REPORT OF PRELIMINARY GEOTECHNICAL INVESTIGATION

**SU CASA
6738 LA JOLLA BOULEVARD
LA JOLLA, CALIFORNIA**

Subject: Addendum Geotechnical Report and Response to Cycle 10 LDR-Geology Review of Documents, City Project Nbr. 420956, Su Casa, 6738 La Jolla Boulevard, La Jolla, California

SITE PLAN AND GEOTECHNICAL MAP

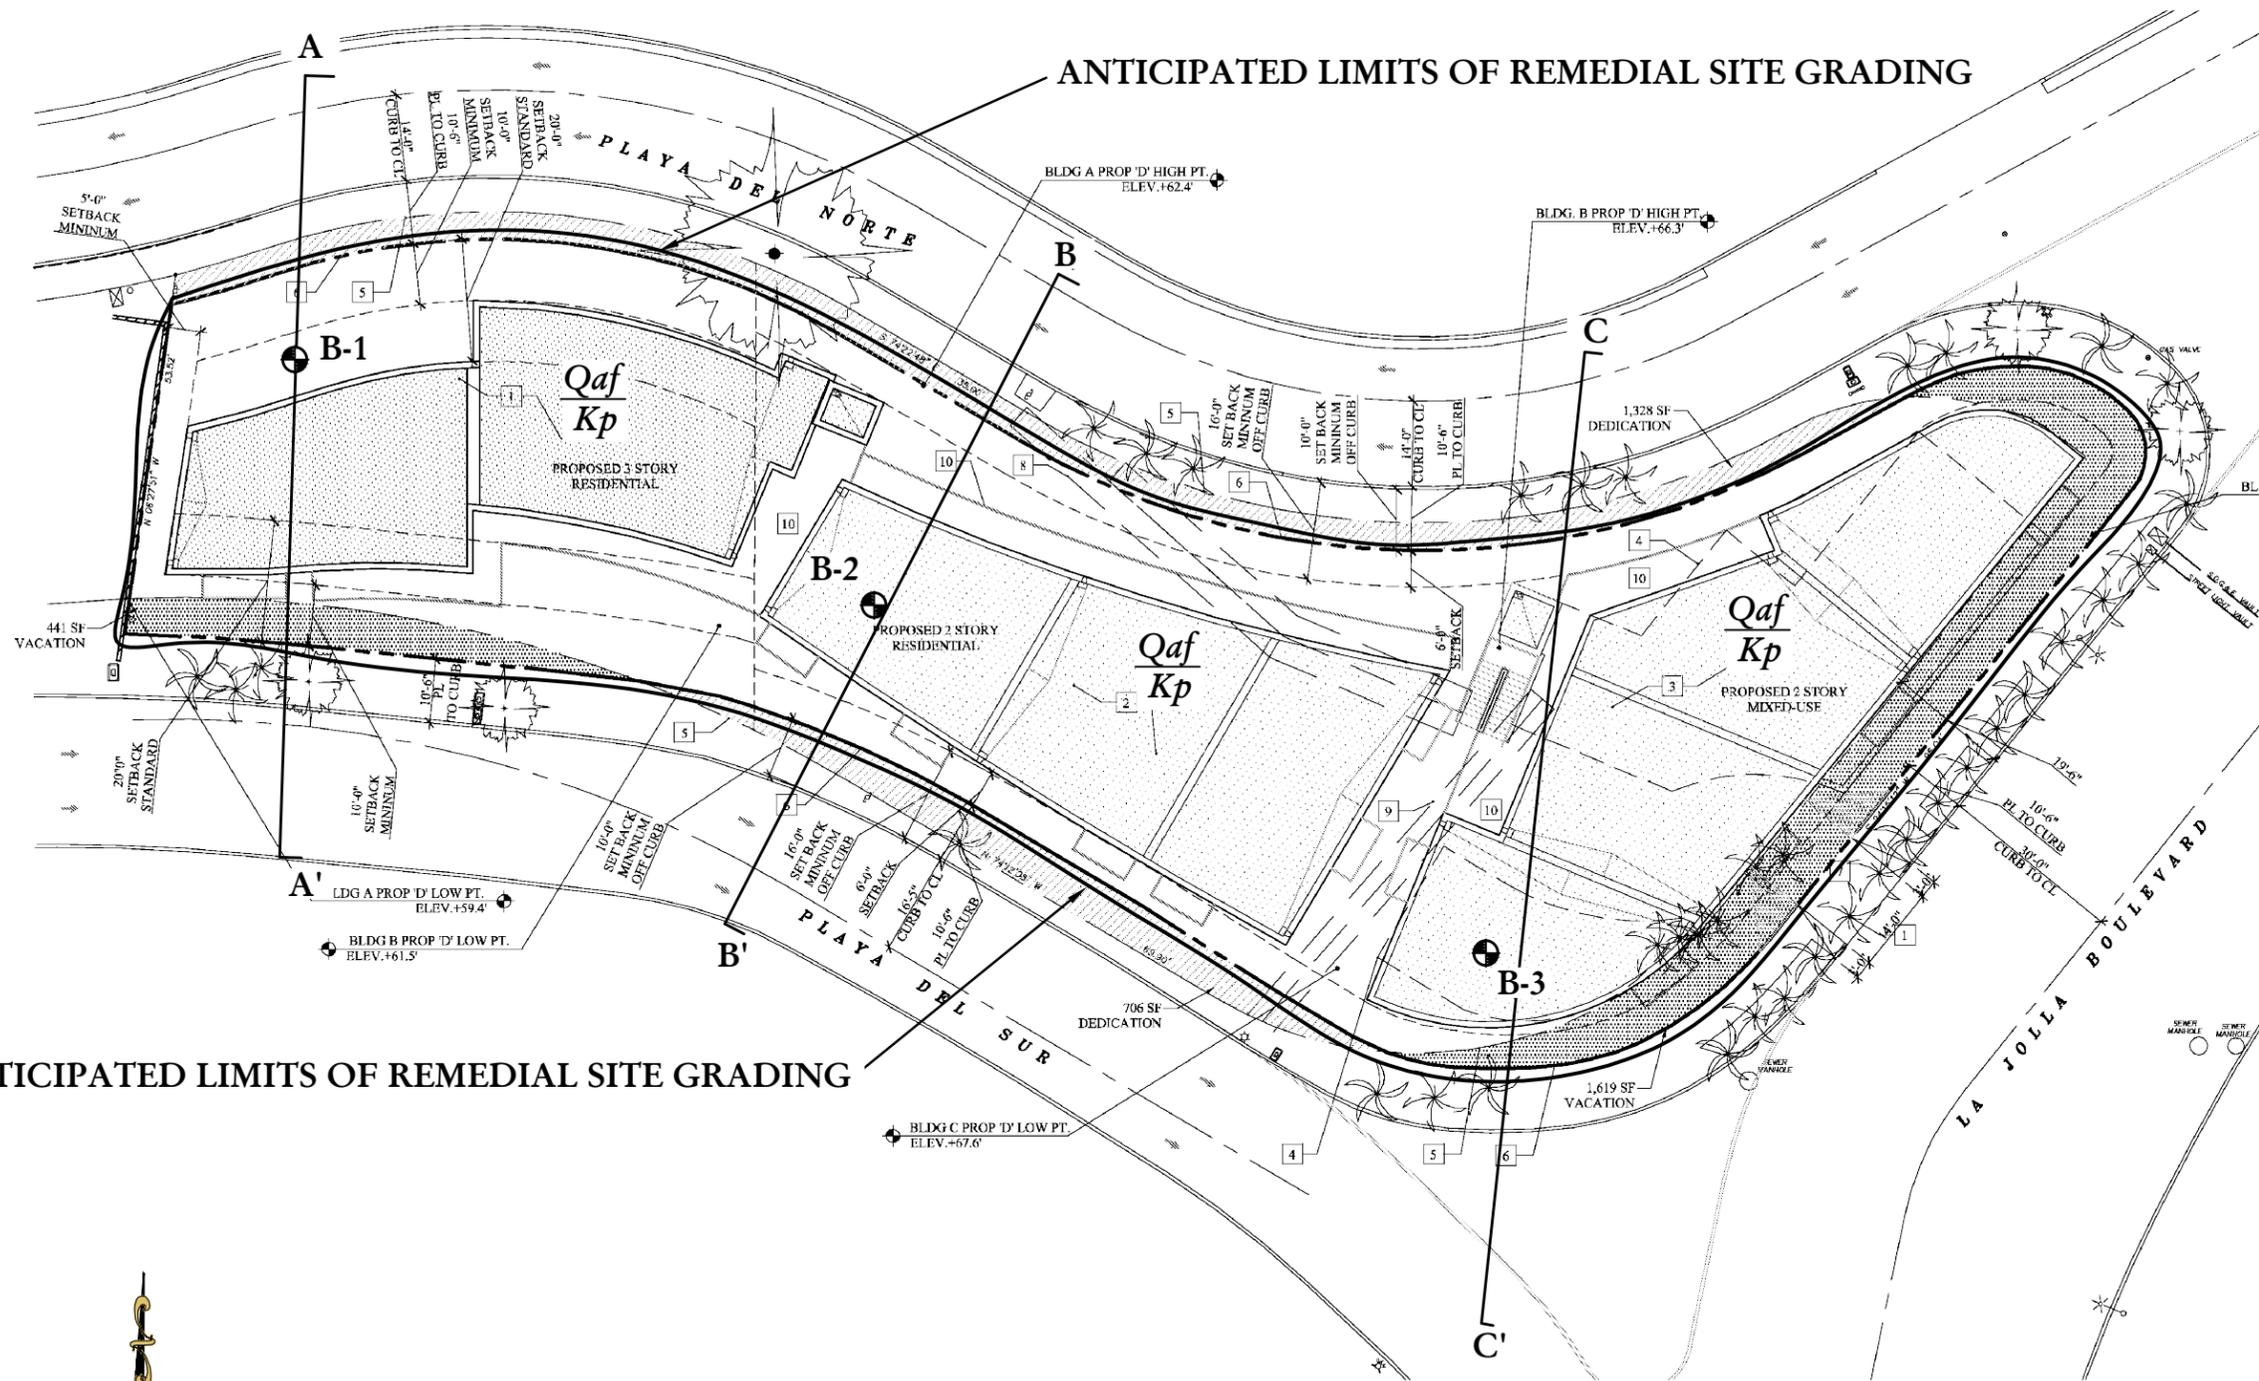
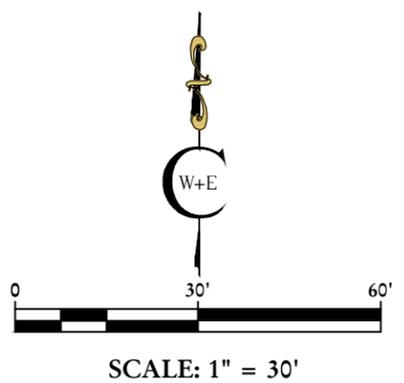
City Comment No. 4: Regional geologic mapping indicates that terrace deposits (i.e. "Bay Point Fm.") rest on the Point Loma Formation in the vicinity of the site. However, the geologic map and cross sections do not show terrace deposits. Clarify if terrace deposits underlie any portion of the site.

City Comment No. 5: If terrace deposits underlie any portion of the site, show the distribution of the terrace deposits on the geologic map and cross sections.

CWE Response: Terrace deposits are not anticipated to underlie any portions of the subject site.
